APPLICATION AND REFERRAL TO THE US COMMISSION OF FINE ARTS FOR OLD GEORGETOWN REVIEW

3114 O Street, N.W. Washington, D.C.

Subject: FW: Conceptual drawings and Old Georgetown Board

PROPOSED PLANS

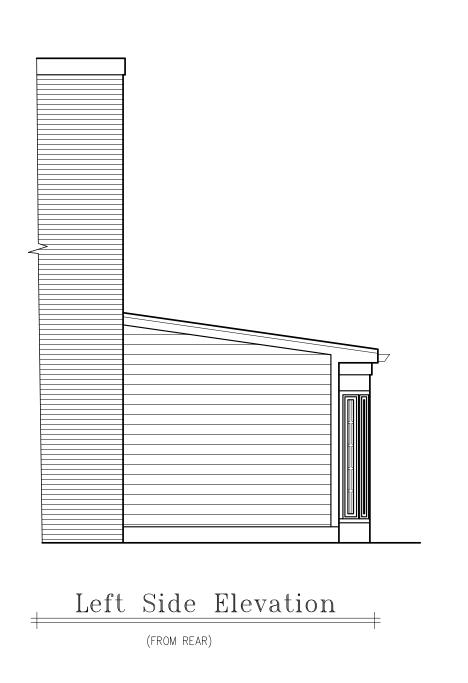
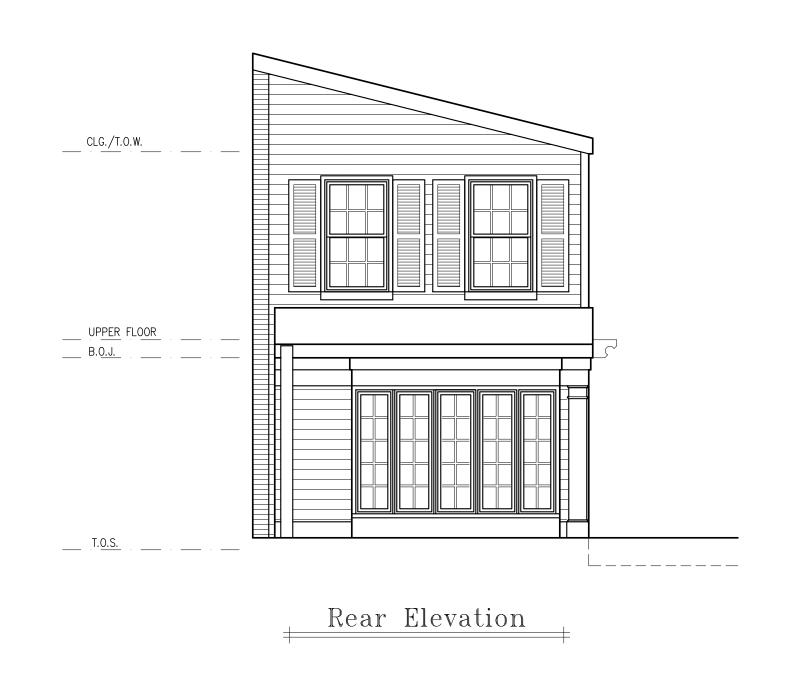
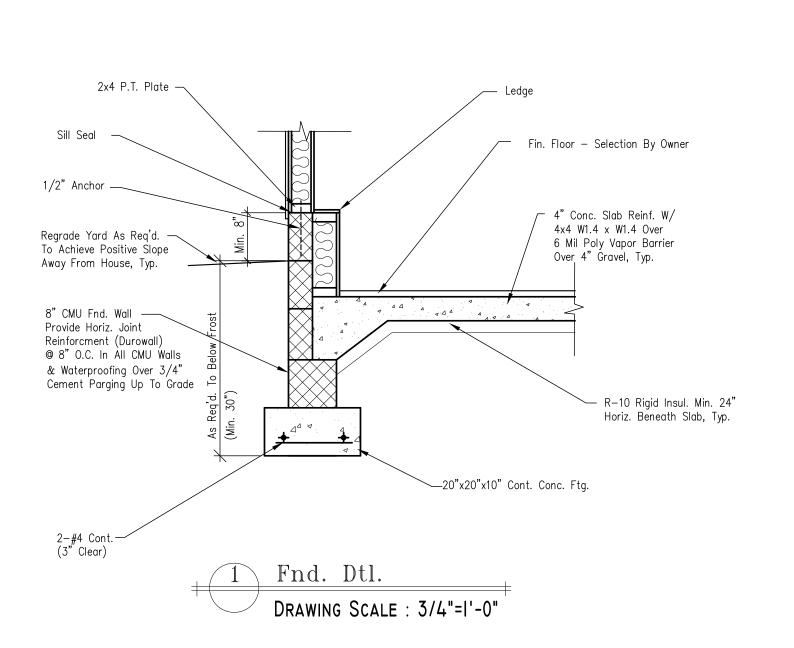
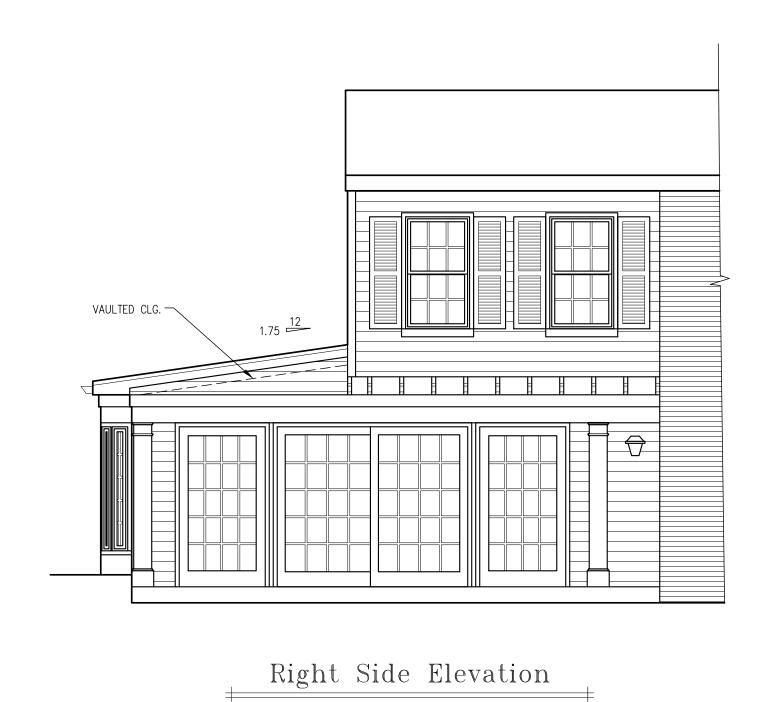
Alright, thank you. When you have them ready, please send me the architectural drawings. For a full review/approval, the final set of plans should include a door/window schedule as well as specifications on roofing materials and exterior lighting fixtures. Take care!

Okay, that should be fine to the Trust. That particular floor has been heavily modified. Were you planning on replicating the existing materials (wood siding)?

Thanks for your patience. I'm not sure how the kitchen addition is different from the current rear, other than you are changing the roofline on the first floor and swapping out the existing window with a bay window. The dimensions look the same.

The room is actually 5 feet longer – extending straight back with same width and same lines into the garden. The doors and windows look the same but they are actually a bit wider so while the number of doors and windows look the same – the wall is 5 feet longer.
